September 2012

EU2000iK1 GENERATORS SAFETY AND EMISSIONS RECALL - STOP SALE/RENTAL NOTICE

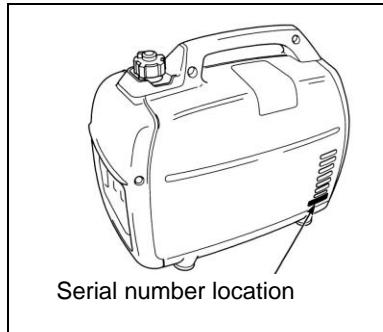
Units within the affected serial number range may have an improperly positioned fuel tube clamp at the fuel tank outlet. The tabs of the improperly positioned fuel tube clamp could wear into an adjacent fuel tube causing a fuel leak.

- Inspect your inventory and confirm if you have any generators within the affected serial number range. If you identify in-stock units, follow the *Dealer Inventory Inspection* procedure on page 2.
- Units within the affected serial number range cannot be sold, or otherwise placed into service, until they have been inspected and if necessary repaired, as required by law. Any injury or damage which occurs from affected units sold after this Stop Sale Notice is the responsibility of the retailer.
- American Honda will be issuing a service bulletin shortly with inspection and repair procedures.
- New units in American Honda inventory within the affected serial number range that have a green sticker on the carton next to the bar code and have a black "DOT" located under the spark plug access panel, have their clamps properly positioned and are not part of this stop sale notice.
